CAT34TS02 ERRATA

Power - Cycling Guidelines for the CAT34TS02/6095 with Device ID: 0x0812

2010–April–13

CAT34TS02/6095 (Device ID: 0x0812) Minimum Down-Time for Effective TS Initialization (Parameter: Power-Down Voltage Level)

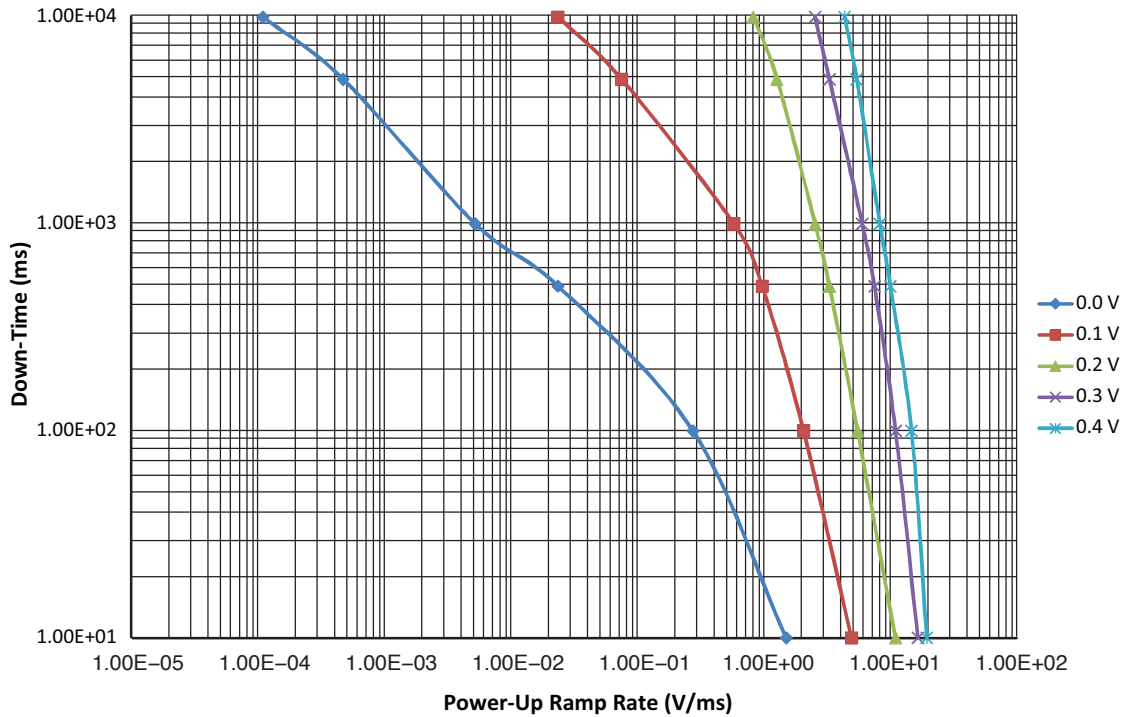
Less down-time is required at higher temperature, but considerably more is needed when not powering down all the way to GND level (as illustrated in the attached single device example).

If necessary, the minimum power-down time can also be determined “in situ” by running a power-cycling routine, whereby the down time is extended until a written Configuration register is eventually cleared following a long enough power-down period.

To prevent unpredictable behavior, it is nevertheless strongly recommended to avoid power-cycling this device during system up-time.
